MIL-R-85664(AS)
AMENDMENT 1
7 JULY 1987

MILITARY SPECIFICATION

RECEIVER-TRANSMITTER, RADIO
RT-1250A/ARC

This amendment forms a part of Military Specification MIL-R-85664(AS), dated 3 June 1985, and is approved for use within the Naval Air Systems Command, Department of the Navy and is available for use by all Departments and Agencies of the Department of Defense.

FIGURE 4. Electronic Equipment Mounting Base MT-4934/ARC and Radio Receiver-Transmitter RT-1250A/ARC, Outline and Mounting Dimensions

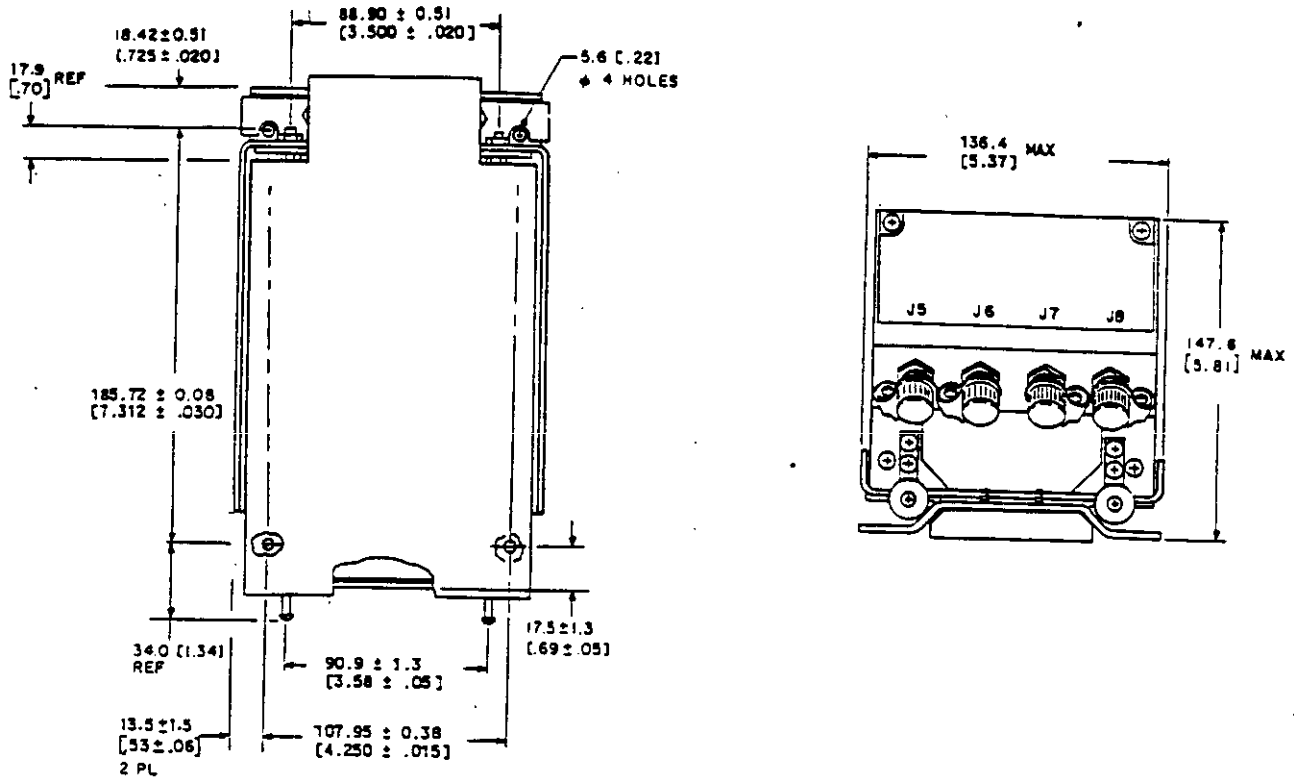
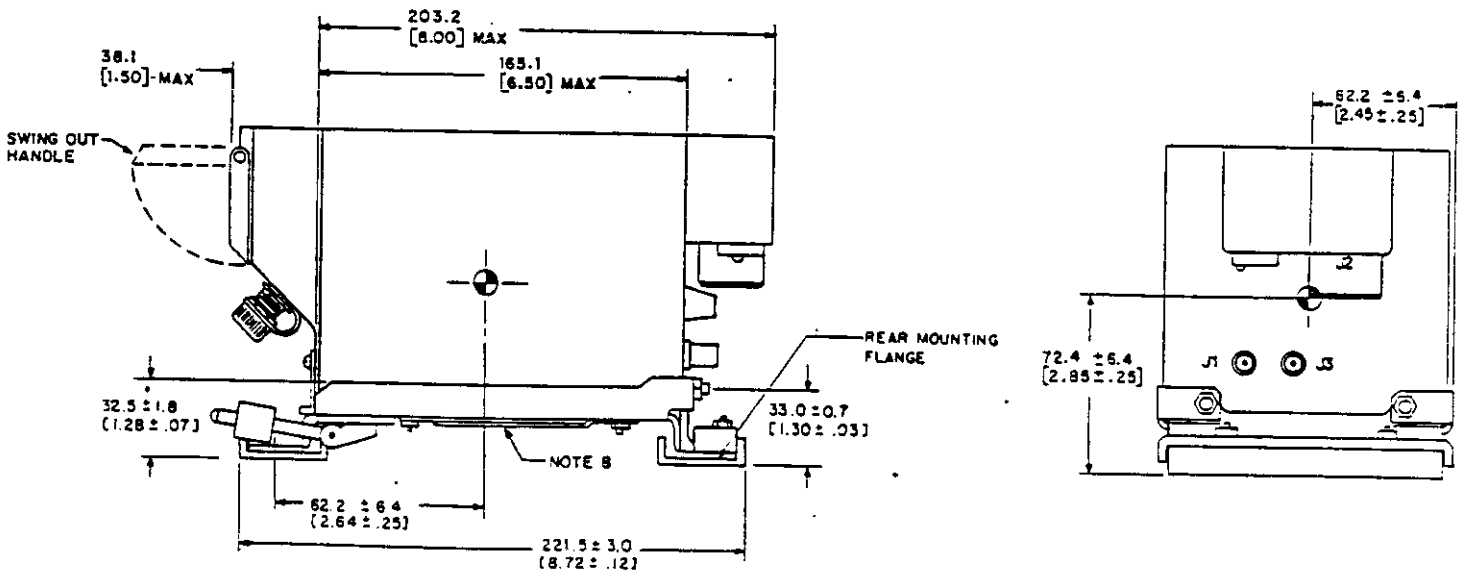
Delete Figure 4 and substitute new Figure 4.
